Access Compliance Report

Public Rights-of-Way

Intersection ID: 5090	Main Street: EDMONTON_PL	Cross Street: SARNIA_PL	Location:	S
ADA ID: 087DB7F68D88	Ramp Type: Perp	Initial Pass/Fail: Fail	Overall Compliance: No	Severity Score: 50

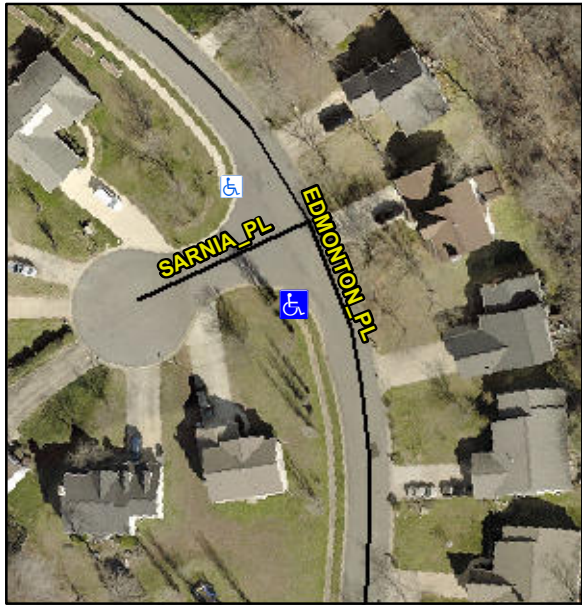
Codes/Mitigation Info/Possible Solution			Field Measurements/Component Compliance					
	Possible Solutions:		Compliance	Description	Data	Compliance	Description	Data
	Remove & Replace Entire Ramp.		N/A	Ramp Length (in)	48.0	No	Ramp Slope (%)	20.0
			No	Ramp Width (in)	47.0	No	Ramp XSlope (%)	3.1
			N/A	Flare Type LT	N/A	N/A	Flare Type RT	N/A
			N/A	Flare Slope LT (%)	N/A	N/A	Flare Slope RT (%)	N/A
			N/A	Flare Traversable LT?	N/A	N/A	Flare Traversable RT?	N/A
			N/A	Landing Length (in)	N/A	N/A	DWS Provided?	N/A
			N/A	Landing Width (in)	N/A	N/A	DWS Contrast?	N/A
			N/A	Landing Slope (%)	N/A	N/A	DWS Length (in)	N/A
			N/A	Landing X Slope (%)	N/A	N/A	DWS Full Width?	N/A
Surveyor Notes:	N/A		N/A	Landing Curb? (Y/N)	N/A	N/A	DWS Offset (in)	N/A
			N/A	Shared Landing?	N/A			
	PROW/ADA:		N/A	Gutter Ponding?	N/A	N/A	Gutter Slope (%)	N/A
	Not Found, R304.5.1, R304.2.2, R304.5.3, R302.7		N/A	Gutter Lip Ht (in)	N/A	N/A	Gutter X Slope (%)	N/A

N/A	Painted X Walk1?	No	N/A	Painted X Walk2?	N/A
				X Walk 1 Direction	To N		X Walk 2 Direction	N/A
			N/A	X Walk 1 Width (in)	N/A	N/A	X Walk 2 Width (in)	N/A
				X Walk 1 Slope (%)	1.2		X Walk 2 Slope (%)	N/A
				X Walk 1 X Slope (%)	1.7		X Walk 2 X Slope (%)	N/A
			N/A	Ramp inside XWalk1?	N/A	N/A	Ramp inside XWalk2?	N/A
			Road Slope (%)	N/A	N/A	Clear Space?	N/A	
			Road X Slope (%)	N/A	N/A	Clear Space to XWalk (in)	N/A	
		N/A	Any Obstructions?	N/A	N/A	Storm Grate/Utility Hazard?	N/A	
			Obstruction Type			Storm Grate/Utility Type		
					N/A		N/A	
					No	Surface Condition? (G/P)	Poor
